West Island, Church Square
 Revised detail for
 Basement. $\frac{1}{2}$ " Scale.

WEST ISLAND - CHURCH SQ
 PRETORIA
 REVISED DETAIL FOR BASEMENT
 19. 12. 1912
 V.S. Rees - pocket

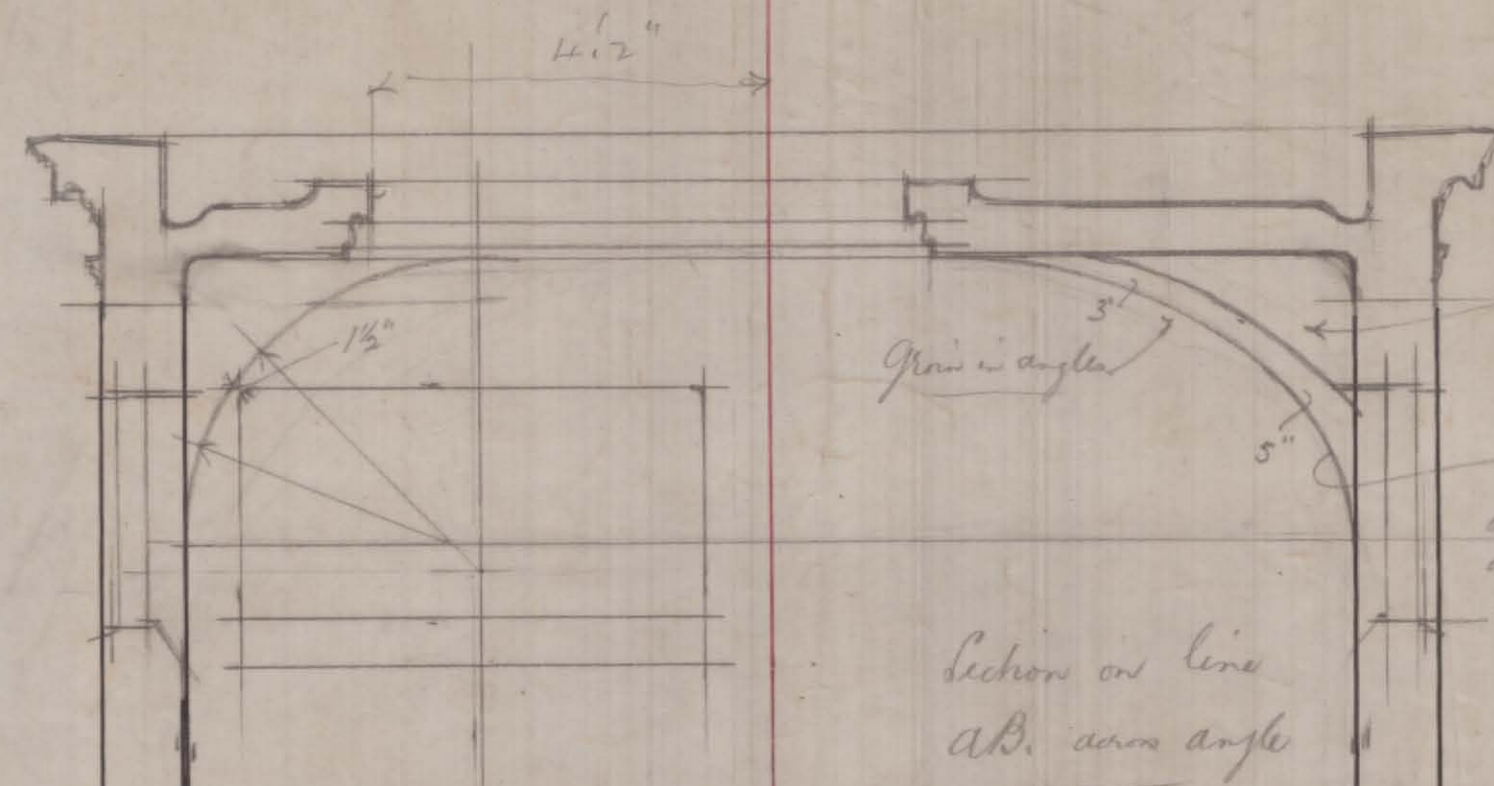
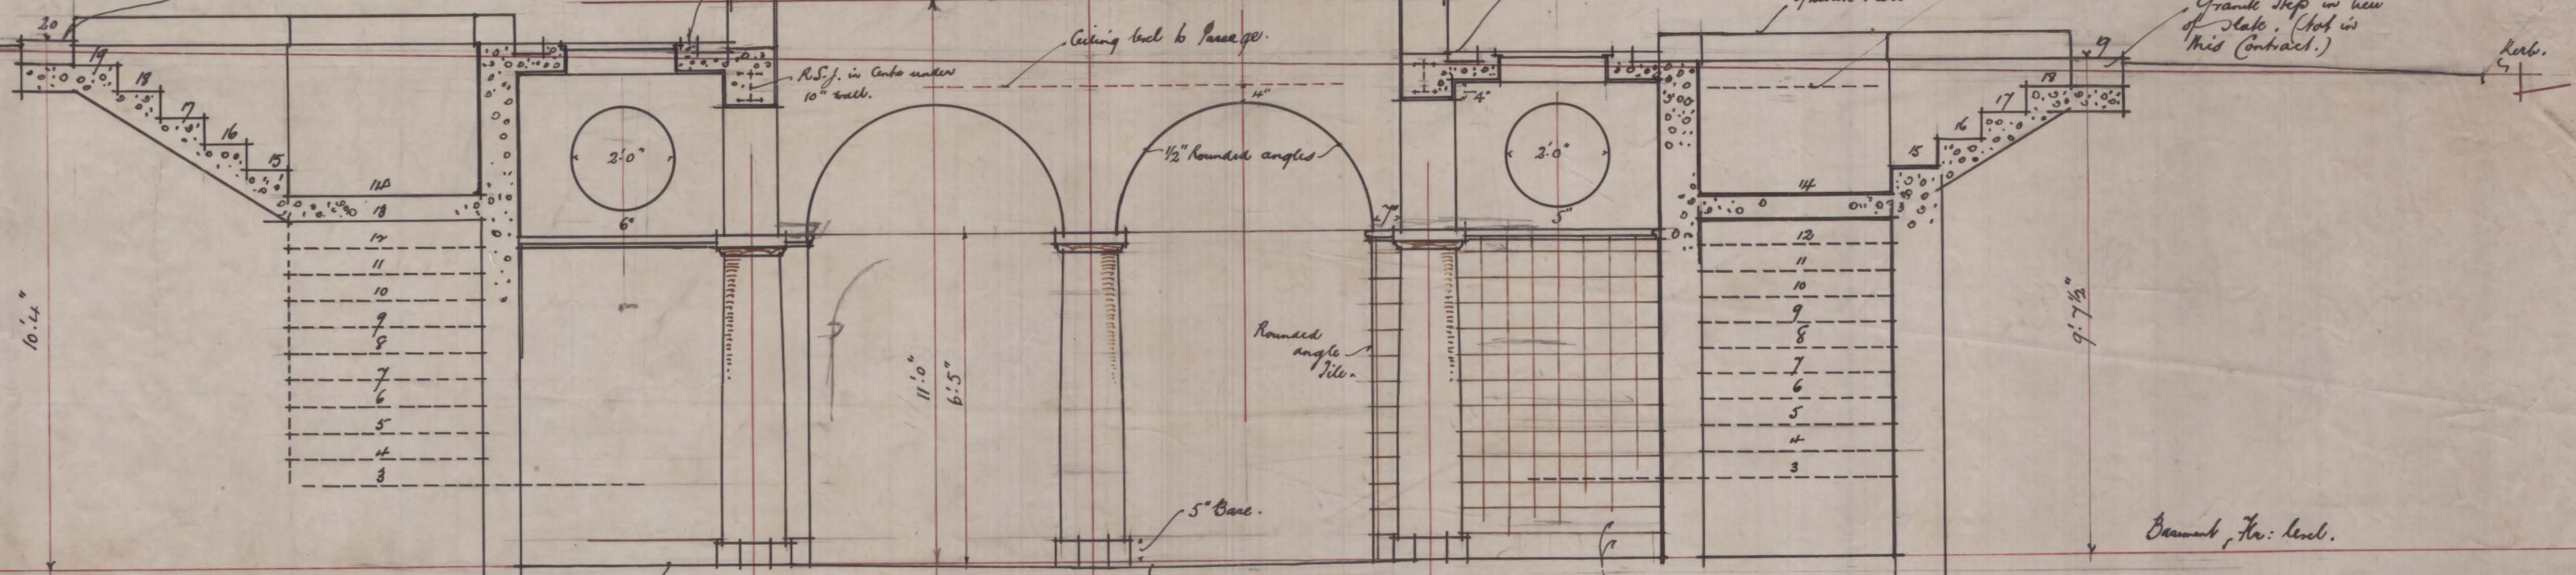
filled in with ashes.
 Piece of 4" x 4" or hoop iron let in at joints of granite to support pier.

Not. Omit all slate paving at ground flr. level.

Granite step in lieu of slate, (Not in this Contract.)

Granite paving in lieu of slate, (Not in this Contract.)

Check levels at this point.

Granite step in lieu of slate, (Not in this Contract.)
